Addendum No. M-03

Reference: Added Scope and clarification

Issue Date: November 12, 2024

Project: UHN TWH – SEM & Corridor (EXP Project Number MRK-23004289-A0)

NO: **M-100B**

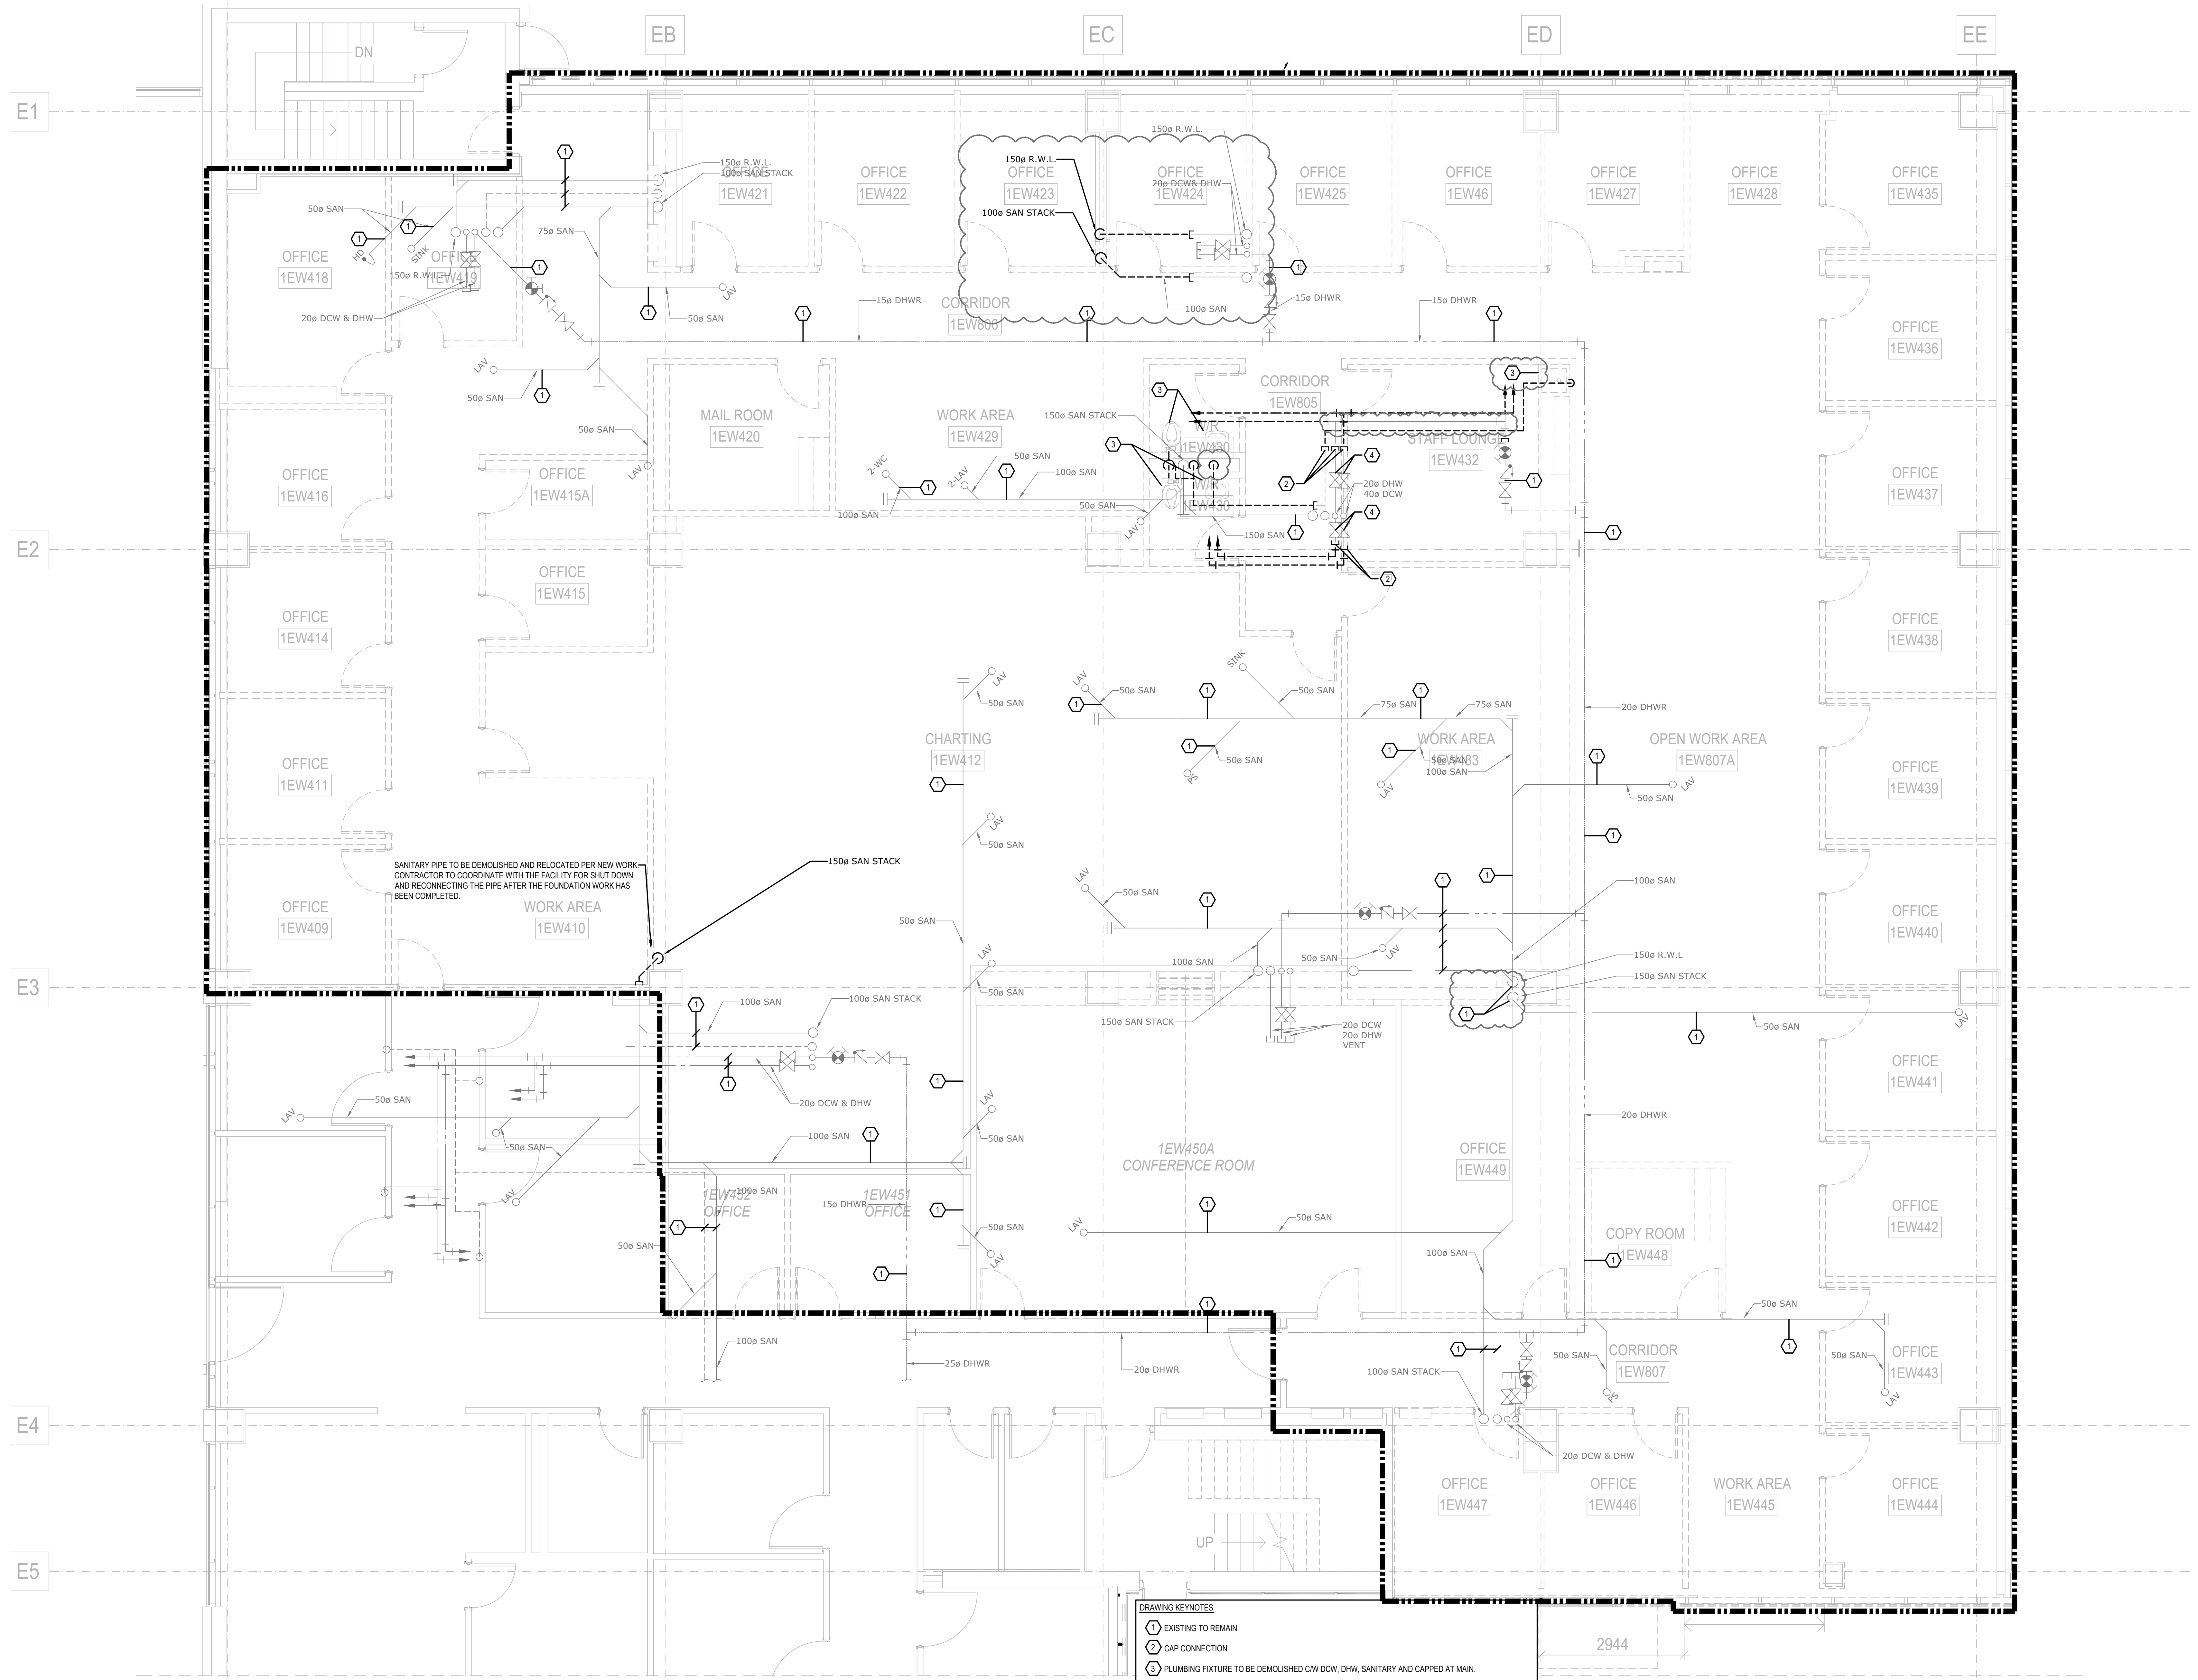
1.1.2. M-100A - CHILLER RELOCATION -DEMOLITION AND NEW WORK - MECHANICAL

- .1 Revised as shown.

TITLE:
LEVEL 1 FLOOR PLAN - CORRIDOR - NEW
WORK - PLUMBING

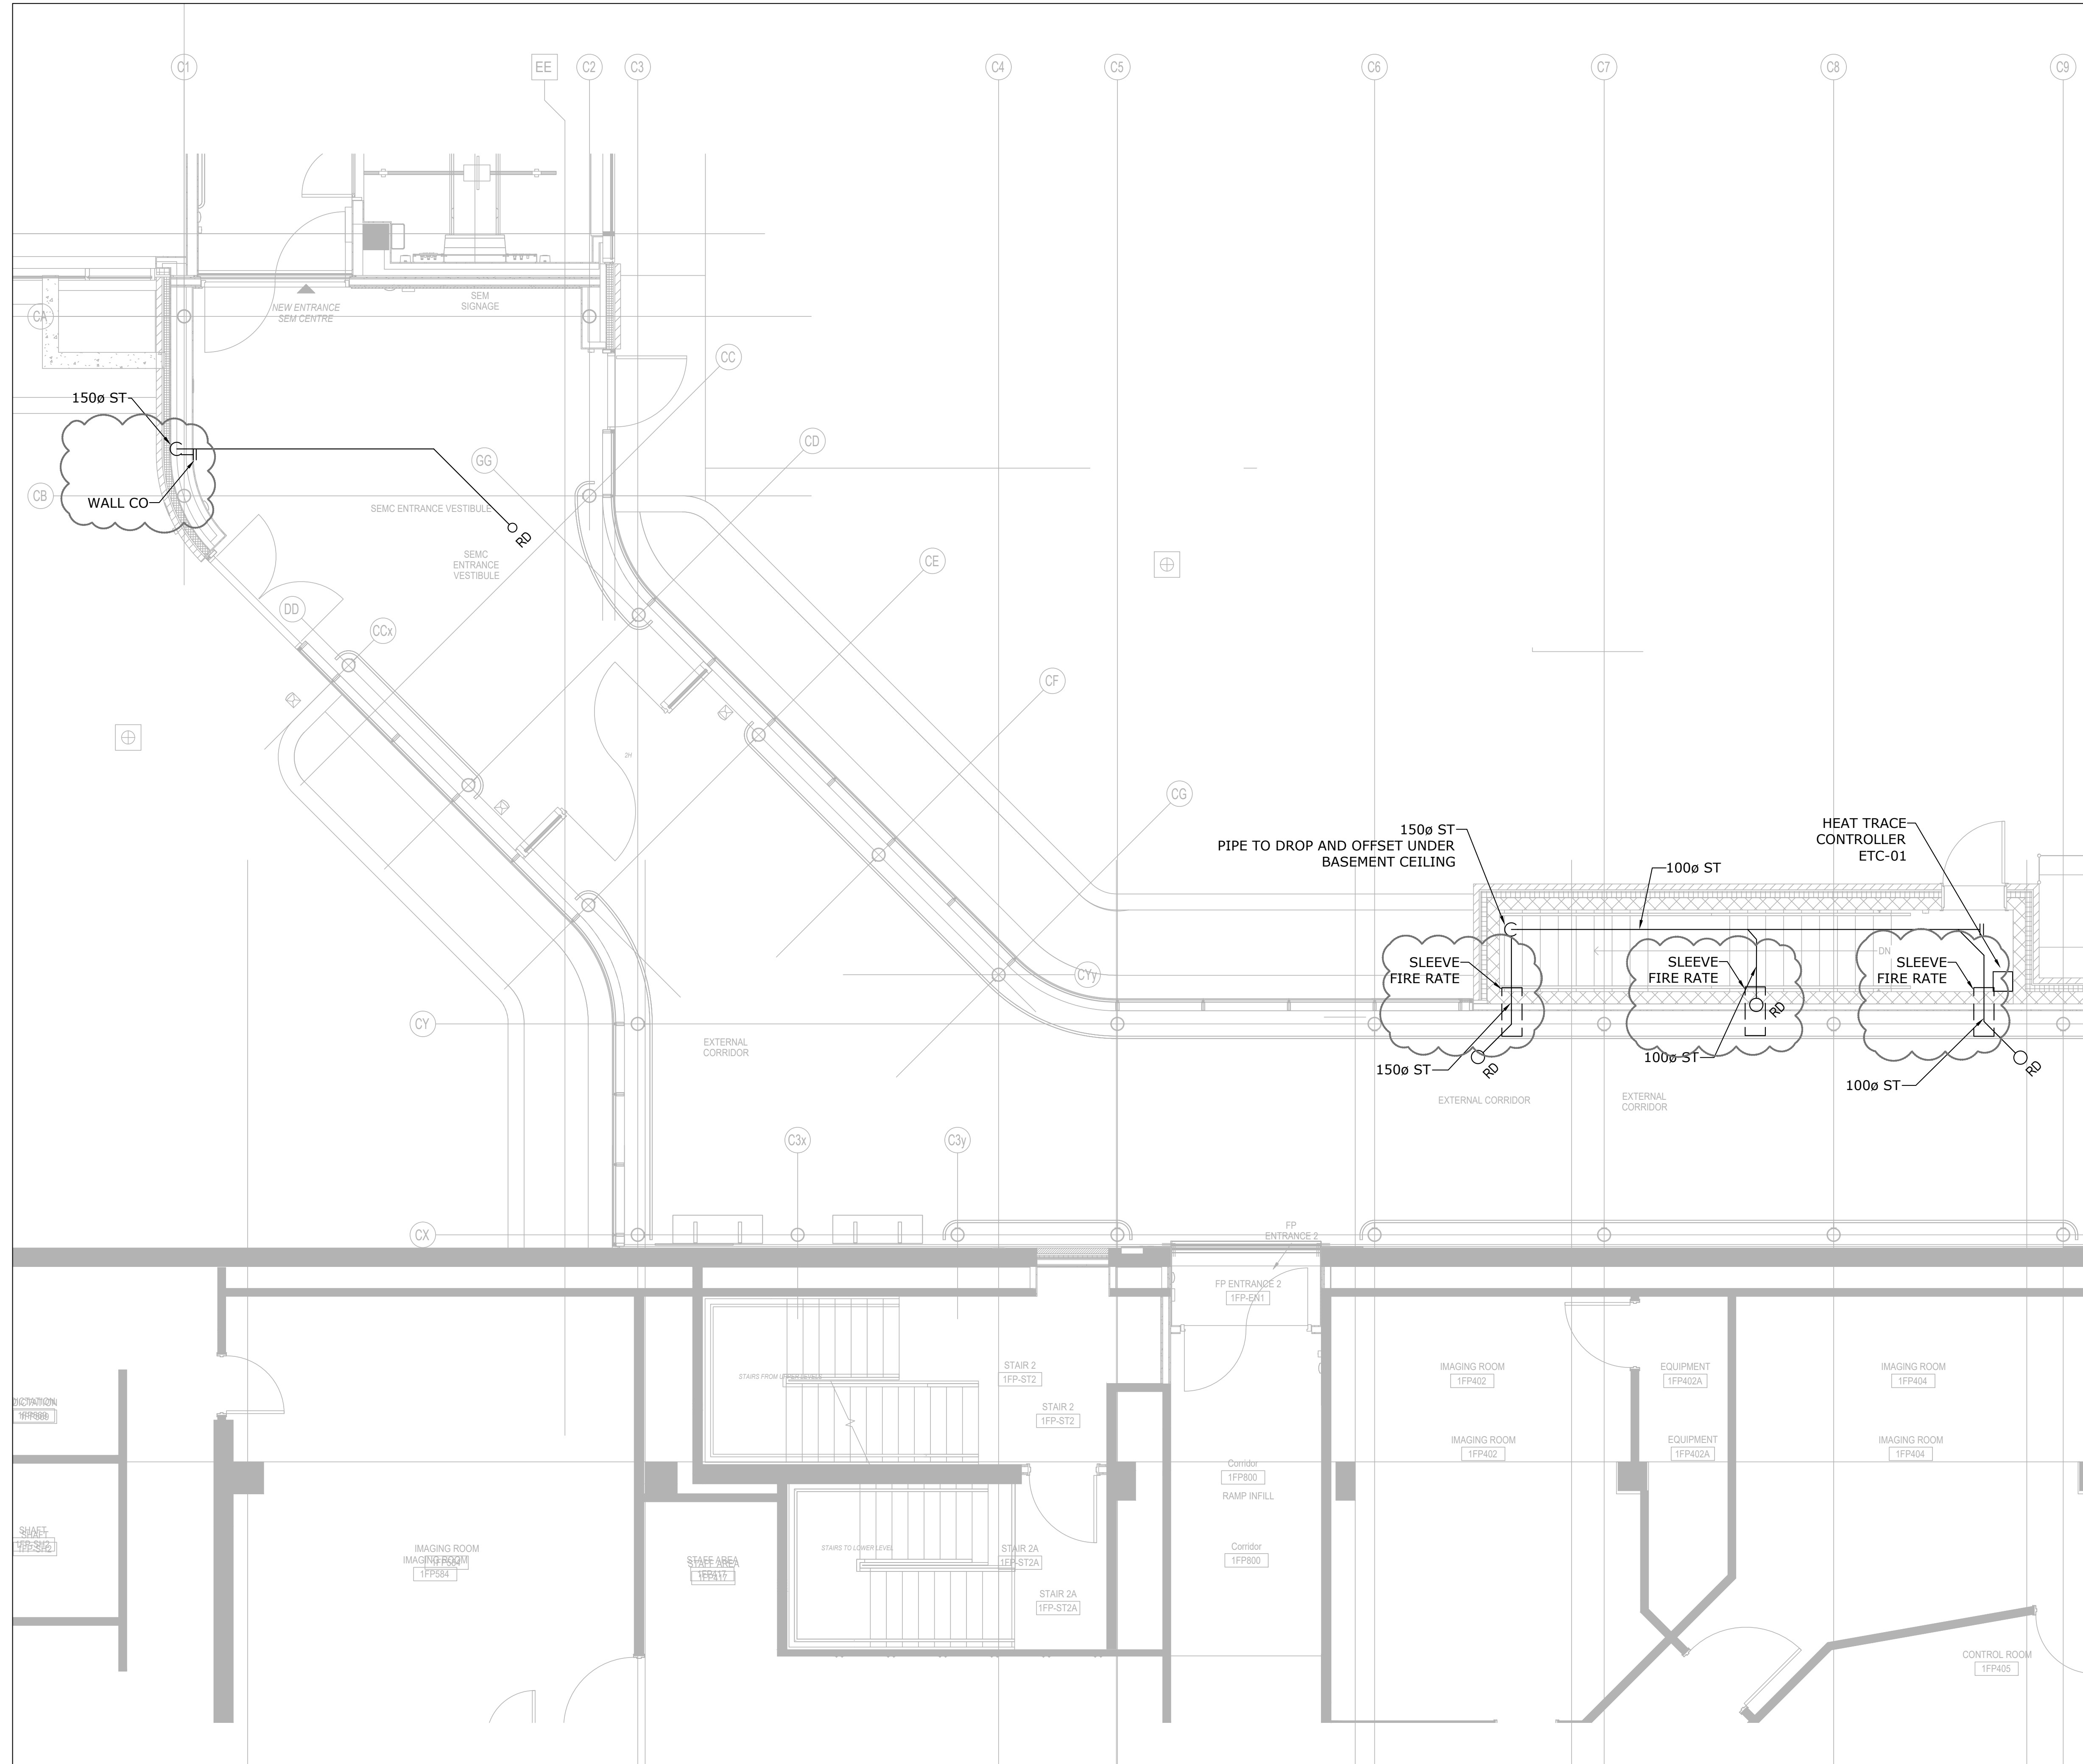
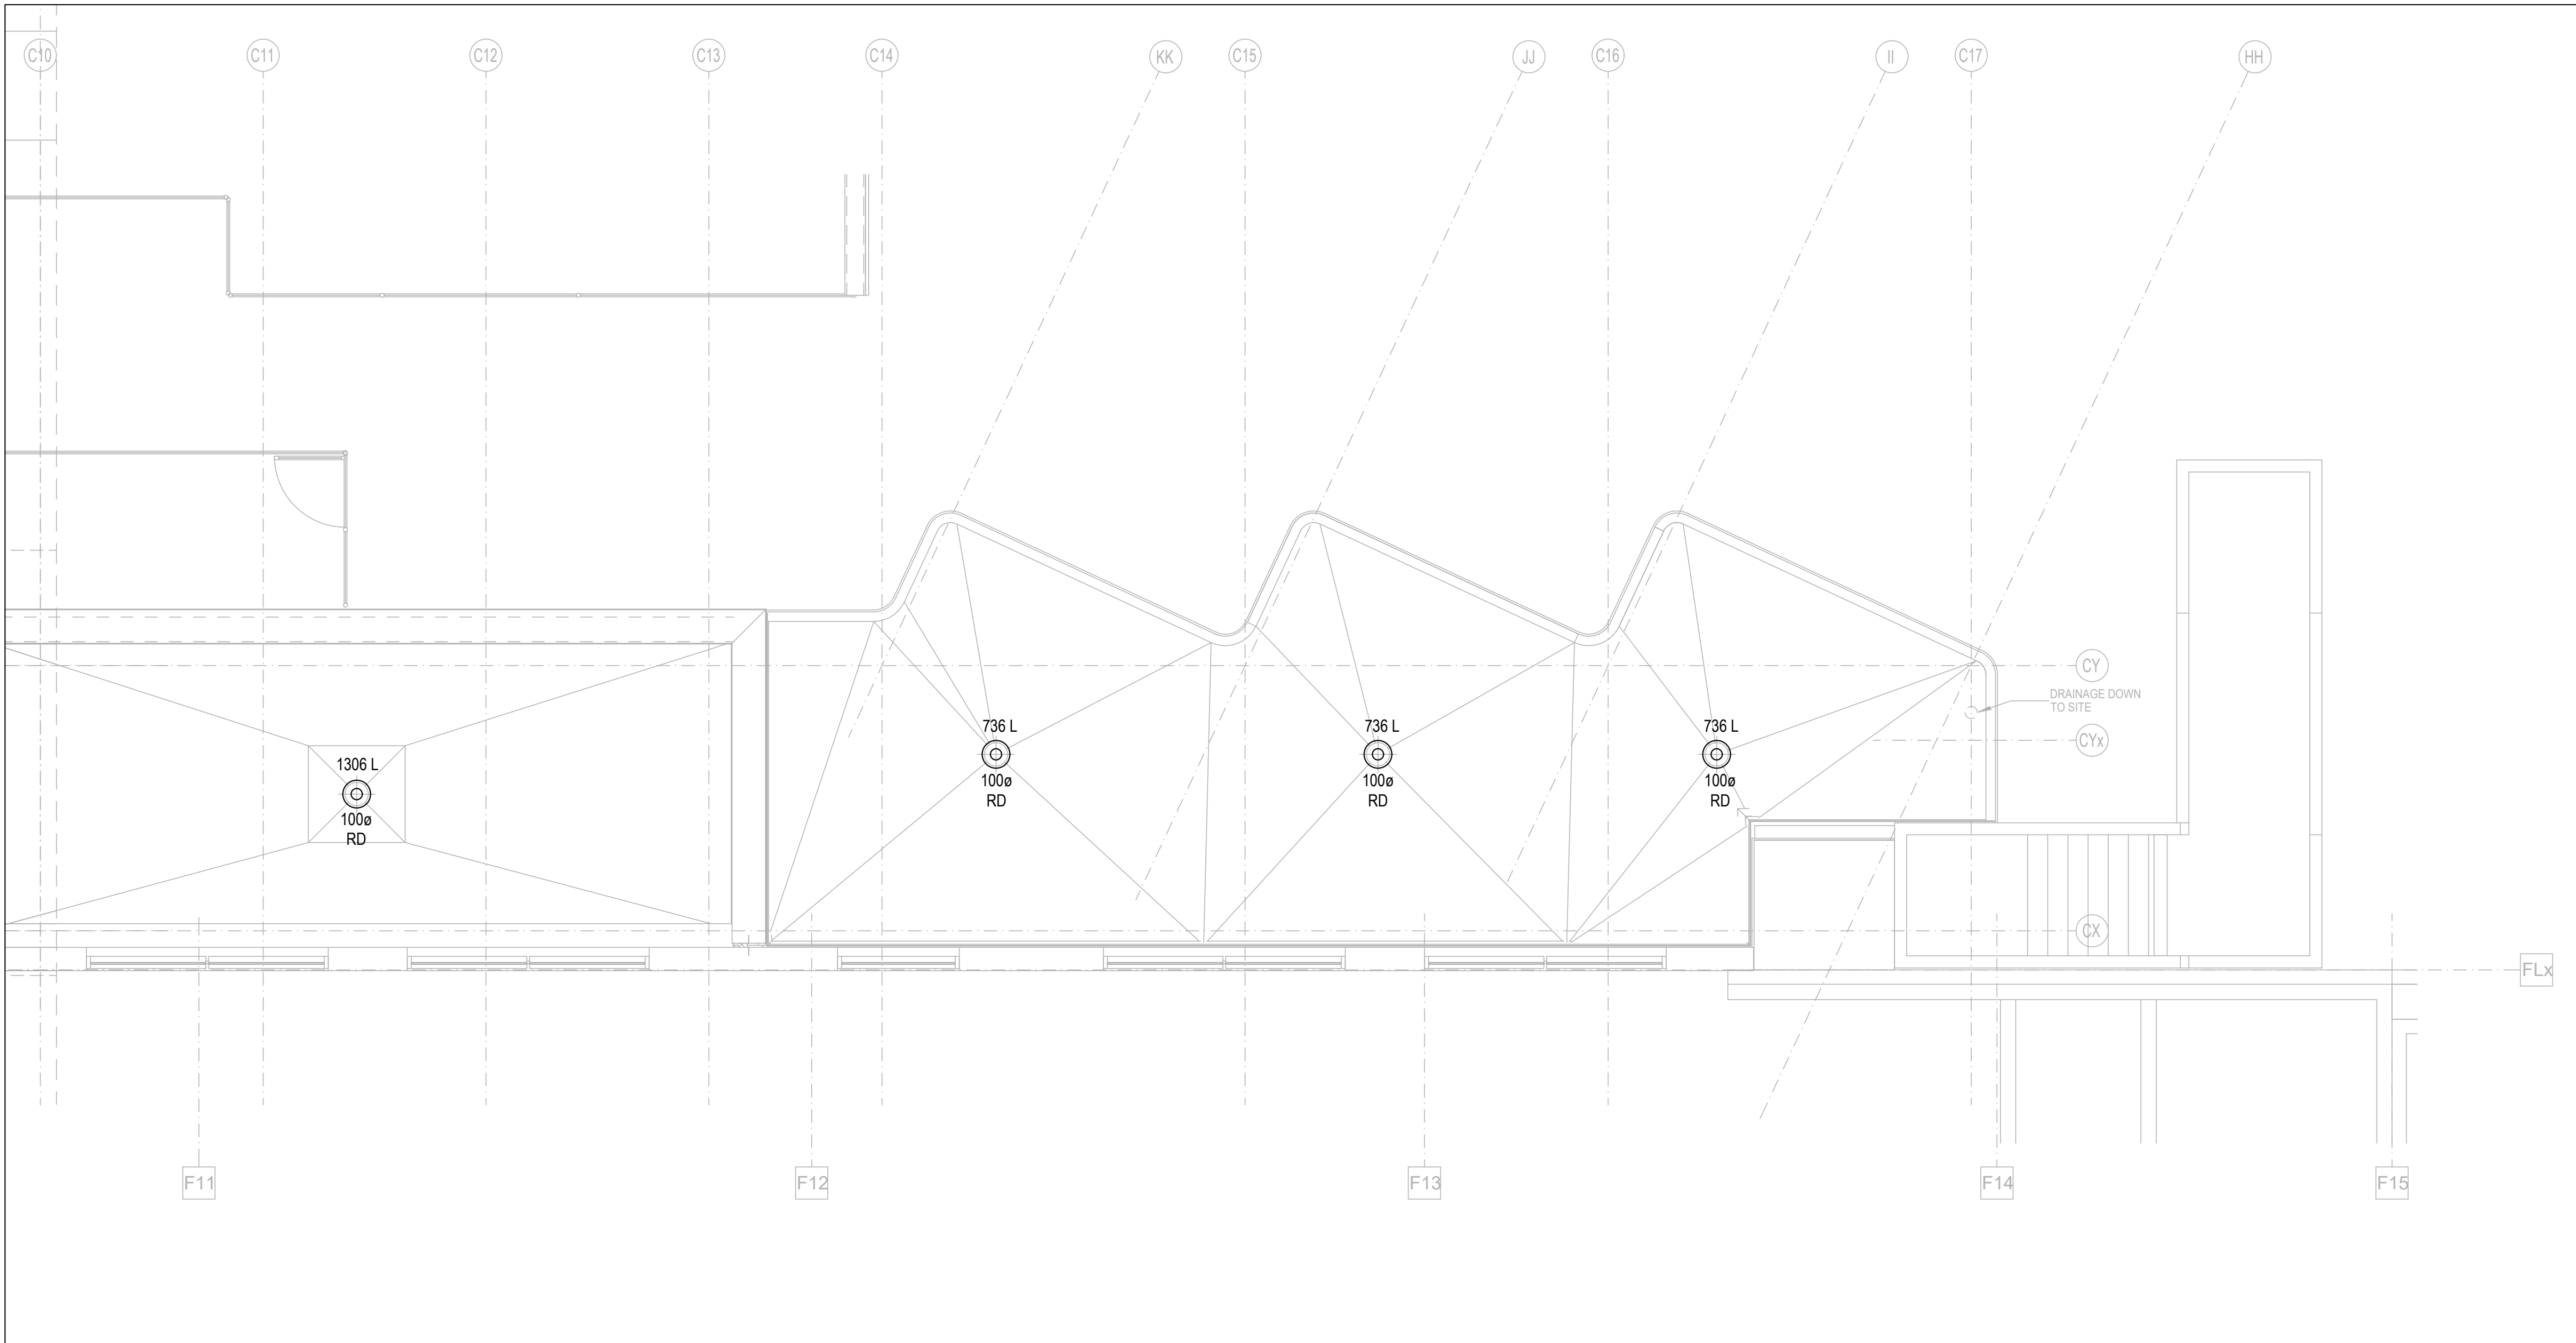
- 1.1.8. **M-114 – LEVEL 1 FLOOR PLAN – CORRIDOR – NEW WORK - PLUMBING**
 - .1 All floor cleanouts have been deleted, wall cleanouts added.
 - .2 Added fire rating for pipe sleeves.
